## Historic Preservation Commission Resolution No. 0713

*Date:* October 2, 2013  
*Case No.:* **2013.0226BC**  
*Project Address:* **665 3<sup>rd</sup> Street**  
*Historic Landmark:* South End Landmark District  
*Zoning:* SLI (Service/Light Industrial) Zoning District  
*Block/Lot:* 3788/041  
*Project Sponsor:* Caroline Guibert, Coblentz, Patch, Duffy and Bass, LLP  
*Staff Contact:* Richard Sucre – (415) 575-9108  
richard.sucre@sfgov.org  
*Reviewed By:* Tim Frye, Preservation Coordinator  
[tim.frye@sfgov.org](mailto:tim.frye@sfgov.org)

## **665 Third Street Historic Building Maintenance Plan**

### Windows, Floors 2 through 5

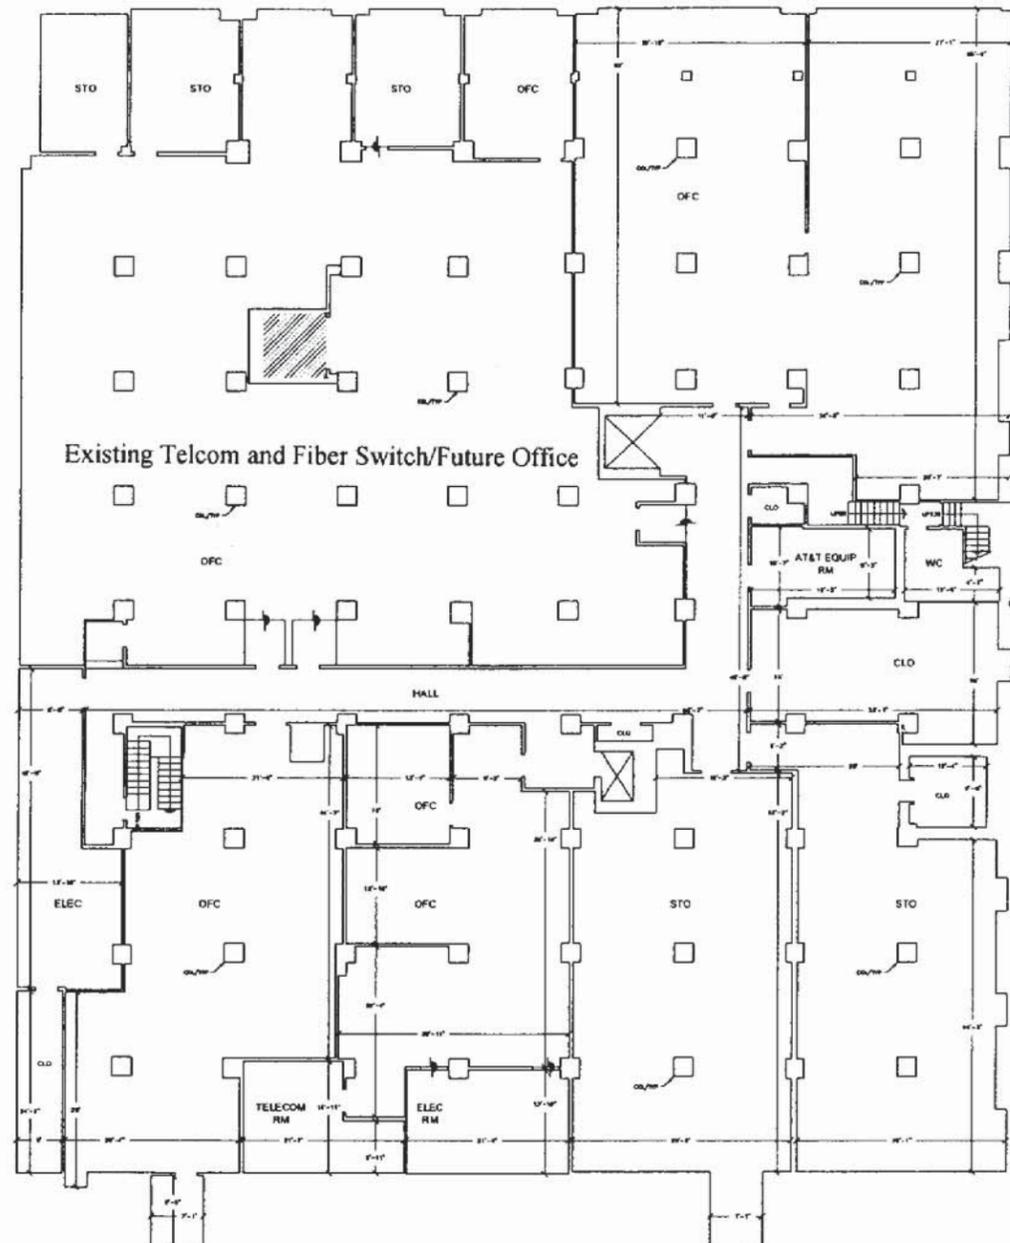
Windows are inspected annually. The annual inspection and repair includes rust abatement, caulking and repair of functional issues. Multi-lite steel sash windows are repaired as necessary to extend the life of the window system as long as possible. If the multi-lite steel sash cannot be repaired and replacement is necessary, new metal sash windows will be installed that match the muntin pattern, sash profile, and divided lite counts on the existing multi-lite steel sash windows. See above regarding contemporary window systems on the ground floor level.

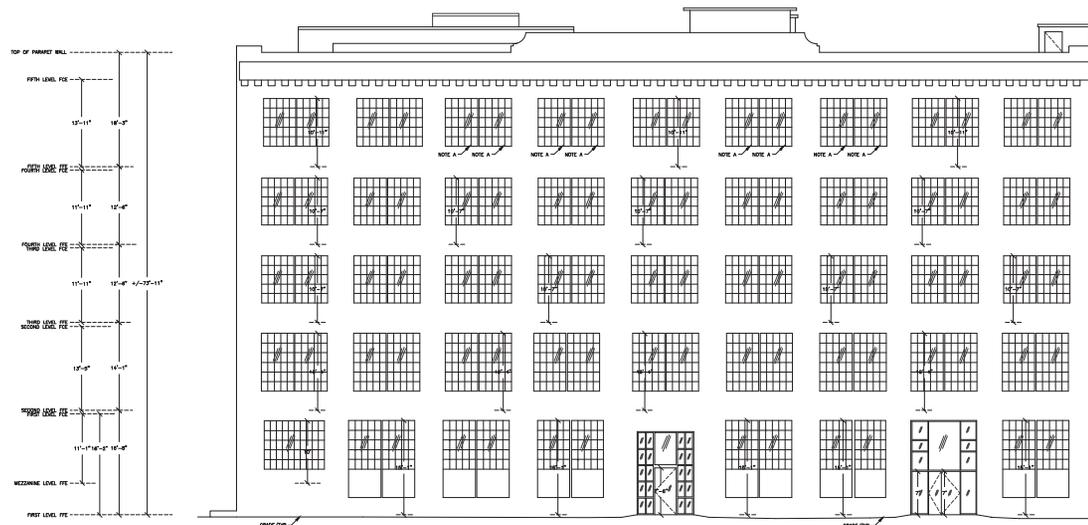
Historic Building Maintenance Plan Summary

**Roof**  
Inspected and repaired annually and replaced every 20 to 25 years.

**Exterior Paint**  
Inspected annually and repainted every 7 to 10 years. A historic paint analysis will be performed within two years to determine the historical color scheme. Planning Department Preservation Staff will be consulted on the historical color scheme before the building is repainted next.

**Exterior Signage**  
No new exterior signage is proposed. The project sponsor has a policy of not allowing tenant signage on the exterior of the building.

**Ground Level Exterior**  
The contemporary window systems and contemporary entry systems on the ground floor level along Third Street will be replaced within two years. As required under Article 10 of the Planning Code, a Certificate of Appropriateness will be obtained for all exterior changes requiring a city permit.

**Windows, Floors 2 through 5**  
Inspected and repaired annually. Multi-lite steel sash windows are repaired as necessary to extend the life of the window system as long as possible. If the multi-lite steel sash cannot be repaired and replacement is necessary, new metal sash windows will be installed that match the muntin pattern, sash profile, and divided lite counts on the existing multi-lite steel sash windows.

**Lobby**  
Historical background information will be displayed in the building lobby to assist in educating tenants and visitors about the history of the MJB Coffee building and the South End Historic District.
